# UNITED STATES PATENT AND TRADEMARK OFFICE

APPLICATION NO.	FILING DATE	FIRST NAMED INVENTOR	ATTORNEY DOCKET NO.	CONFIRMATION NO.
10/517,273	12/09/2004	Bernhard Podirsky	PIZ-106	2781

<b>Office Action Summary</b>	<b>Application No.</b> 10/517,273	<b>Applicant(s)</b> PODIRSKY, BERNHARD	
	<b>Examiner</b> Chi Q. Nguyen	<b>Art Unit</b> 3635

### **DETAILED ACTION**

FIG. 1.

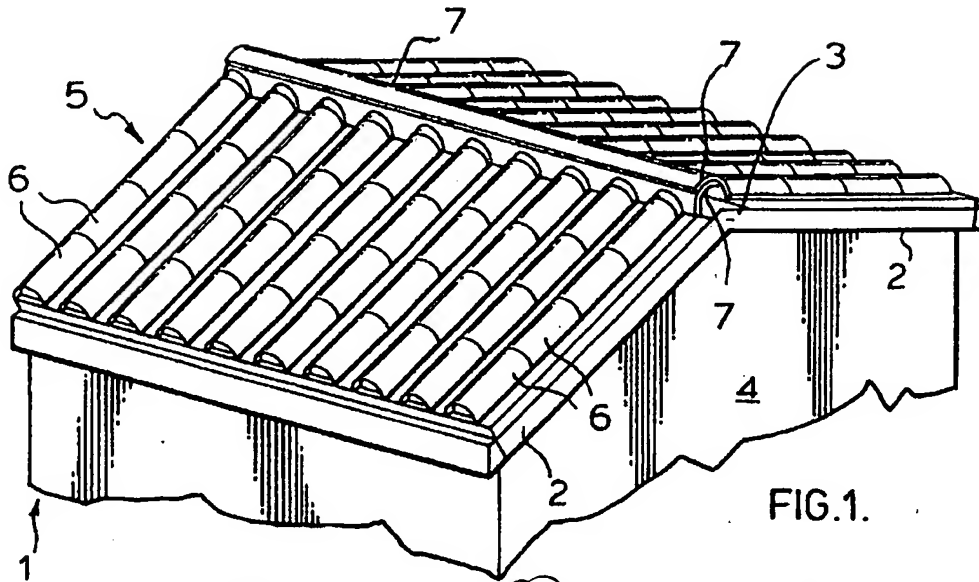
complementary inter-engaging means 18 provided on respective said opposed ends and permitting substantially weatherproof engagement between adjacent body members when laid in longitudinal sequence (see Figs. 1-2).

Wherein the body member portion overlying said roof is adapted to impede the ingress of weather under said body member in use (see Fig. 1).

Wherein said roof comprises a shingle laid roof, said roof batten having a profile selected to conform to said shingle laid roof (see Figs. 1-2).

Wherein mating faces of said overlapping skirt portion and said underlying skirt portion are provided with complementary surfaces features cooperating in use to form a weather impeding labyrinth (see Fig. 1).

FIG. 2.

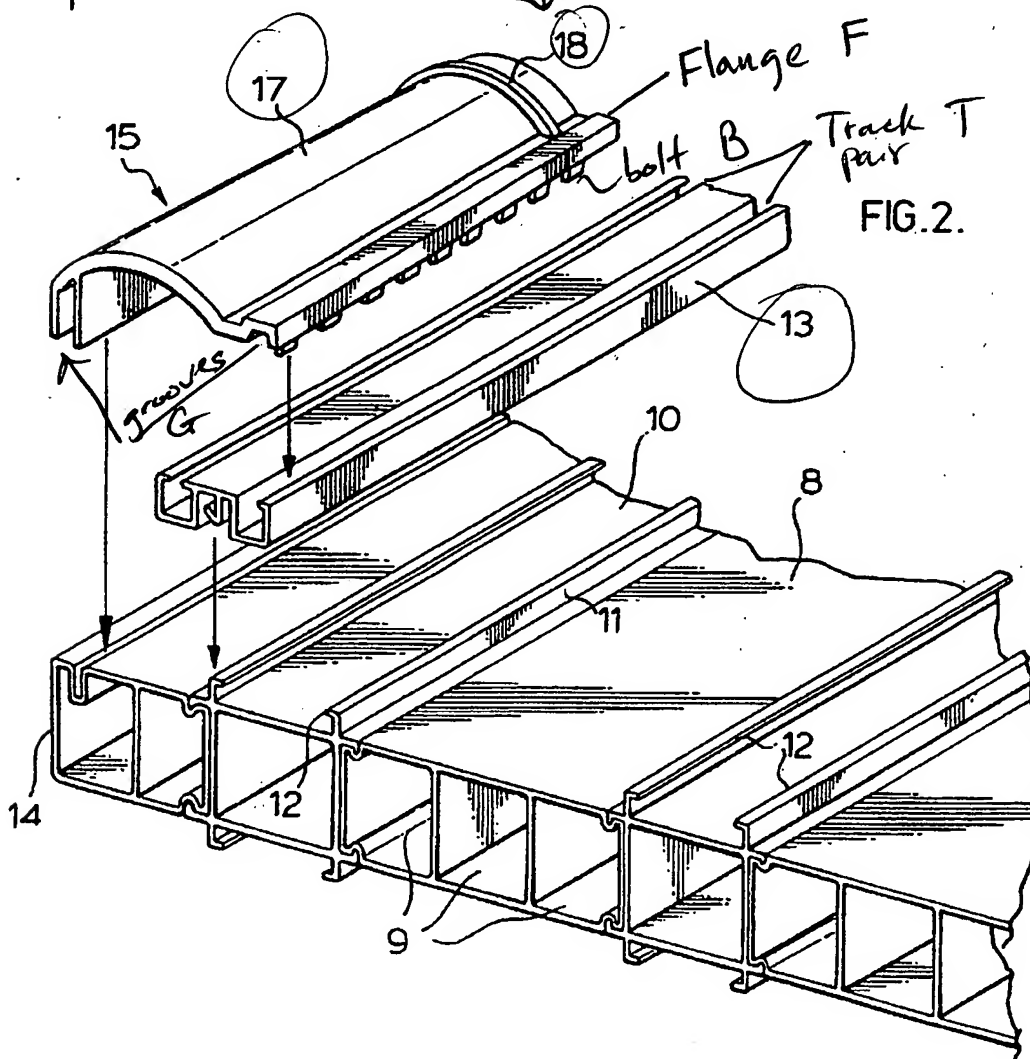
De Zen discloses a cladding apparatus for covering the junction between a roof and a fascia of a building, wherein said apparatus comprises: an elongated body member 15 having an inner surface and an outer surface, each surface extending between opposed ends and opposed elongate side edges of the body member; a mounting batten 13 associated with said fascia 2 and adapted to engage at least one complementary mounting portion provided on said inner surface (no labeled but shown in Fig. 2);

As best understood, De Zen discloses the claimed invention and wherein the adaptation of said body member portion 17 overlying said roof is a flange F (see attachment of Fig. 2) dependent toward said roof from, and extending along, said elongate edge, said roof being provided with an elongate roof batten 14 sealingly supported on said roof, said roof batten including an upper surface against which the inner surface of said body member bears in use (see Fig. 12), one or both of said inner surface and upper surface being provided with one or more elongate grooves forming in use a moisture excluding labyrinth between said inner surface and said upper surface.

Wherein said mounting portion and mounting batten are provided with complementary profiles permitting snap-in connection therebetween (see Fig. 2).

Wherein said mounting portion and mounting batten are provided with complementary profiles permitting connection therebetween by longitudinally sliding said mounting portion on said mounting batten (see Fig. 2).

Wherein said mounting portion and mounting batten are substantially continuous along their respective lengths, whereby said body members are sequentially installed by sliding from one end of said mounting batten (see Fig. 2).

Wherein said mounting portion and mounting batten are complementarily interrupted whereby said body members may be sequentially installed by offering up said body members to said batten intermediate its ends and sliding said body members into engagement with said batten (see Fig. 2).

Wherein said complementary profiles comprise a longitudinal bolt B and track pair T (see attachment of Fig. 2).

Fig. 12), one or both of said inner surface and upper surface being provided with one or more elongate grooves G (see attachment of Fig. 2) forming in use a moisture excluding labyrinth between said inner surface and said upper surface; a mounting batten 13 associated with said fascia and adapted to engage at least one complementary mounting portion provided on said inner surface, said mounting portion and mounting batten being substantially continuous along their respective lengths and provided with complementary profiles permitting connection therebetween by longitudinally sliding said mounting portion on said mounting batten by sliding from one end of said mounting batten (see Fig. 12).

member 13 attachable to the cladding surface (see Fig. 2) said member having means (see Fig. 2) lying in a first plane for inter-engagement with a first portion of the cladding member; and at least one longitudinal connecting batten member 14 attachable to a cladding surface having means (which is a groove show in Figs. 2 and 14) lying in a second plane disposed at an angle to said first plane, for inter- engagement with a second portion of said cladding member and having means (projections from an inner surface of the cladding member) lying in a plane disposed parallel to said first plane for inter-engagement with a portion of an adjacent cladding member (see Figs. 2 and 14).
